Technical Bulletin

Mettler-Toledo, Inc.
Scales & Systems

Number: MTFW-02-01
Date: 01-12-01
Model: 645
Subject: Infeed Door Stop

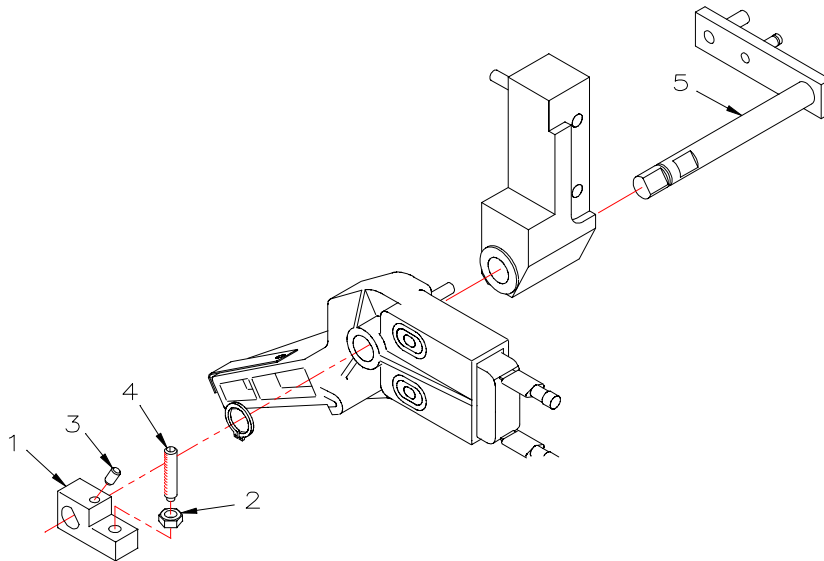
The infeed door actuator lever and stop has been redesigned to improve reliability. A flat has been machined on the shaft of the actuator lever and the stop is locked on the machined flat using a set screw. Stop adjustment is then made by means of a nylon tipped set screw and a jam nut. 645 Wrappers beginning with S/N 3093469-3AC include these new parts.
